Government of Madras.

P. W. DEPARTMENT.

No. 335. From the Superintending Engineer, 5th Division, to the Secretary to Government, Department Public Works, dated Cuddalore, 11th February 1868, No. 224.

Proceedings of the Madras Government, Public Works Department
21st April 1863.

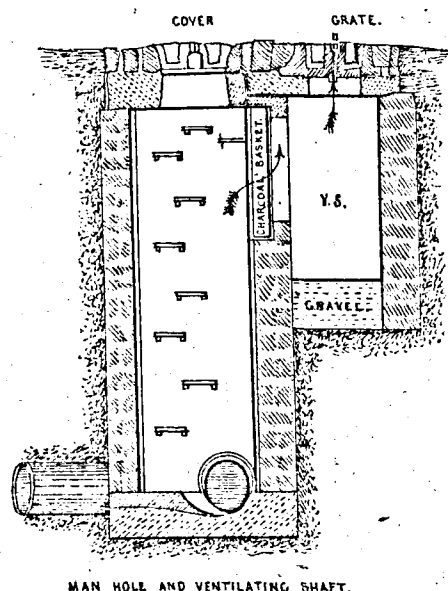
15. *Position of manholes and ventilators.*—In Captain Pennycuick's scheme the manholes and ventilators are at different (alternating) points. The Barrack and Hospital Improvement Commission recommend a combination of the two, and give a drawing of the same, which is re-produced in the margin. Captain Pennycuick has not yet prepared drawing of the manholes and ventilators that he proposes to adopt.

It will probably be found more convenient, economical, and advantageous on sanitary grounds to combine the two, and to introduce the charcoal screen, as shown in the drawing.

It is true that the ventilating shafts open in every case, as shown in the plan, at a distance from any building, still the addition of charcoal filters will be safe and advisable.

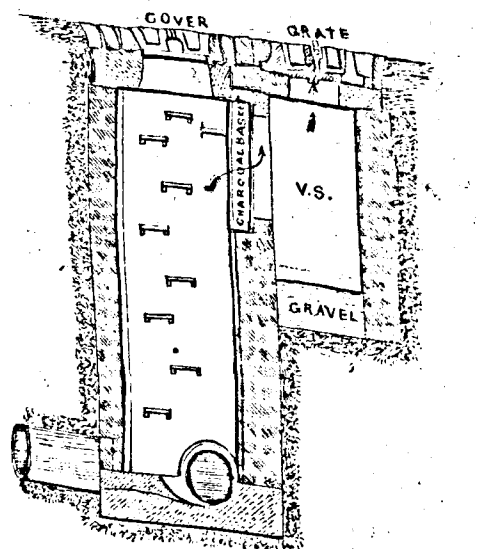
2nd Position of manholes and ventilators.

Improvement Commission recommend a combination of the two and give a drawing of the same which is reproduced in the margin. Captain

Pennycook has not yet prepared drawing of the manholes and ventilators that he proposes to adopt.

17. 15
It will probably be found more convenient economical and advantageous on sanitary grounds to combine the two and to introduce the charcoal screen as shown in the drawing.

It is true that the ventilating shafts open in every case as shown in the plan at a distance from any building, still the addition of charcoal filters will be safe and advisable.
